# **Planning Commission Staff Report**

November 9, 2011 Item 6.b.

SUBJECT: P11-0709 / P11-0717

**PURPOSE:** Applications for Design Review approval to replace the

Figure 3.a: Proposed First Floor Plan

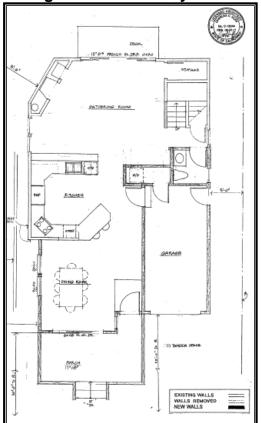
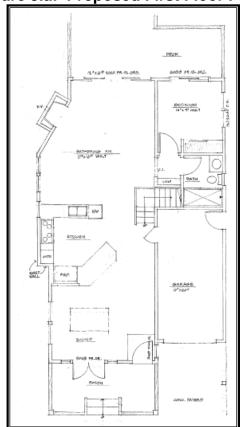
Since the Planning Commission work session, the applicant has reconfigured the first and second floor plans, removed the balcony on the rear elevation, and relocated the balcony on the front elevation. Please refer to Figures 3 through 4 for changes to the floor plans. Staff has also included the Preliminary Review plans as Exhibit G for the Commission's reference.

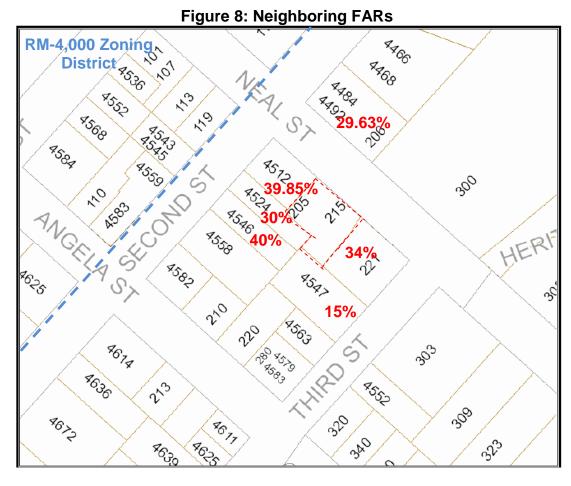
The proposed home would be located on a lower pad from the house located at 215 Neal Street, approximately 2,808 square-feet in size, that has the appearance of and function as an independent lot. The massing of the proposed house in relation to the building area of this lower pad, in staff's opinion, is not consistent with the DTSP policy. This issue is discussed further in the floor area ratio (FAR) section below.
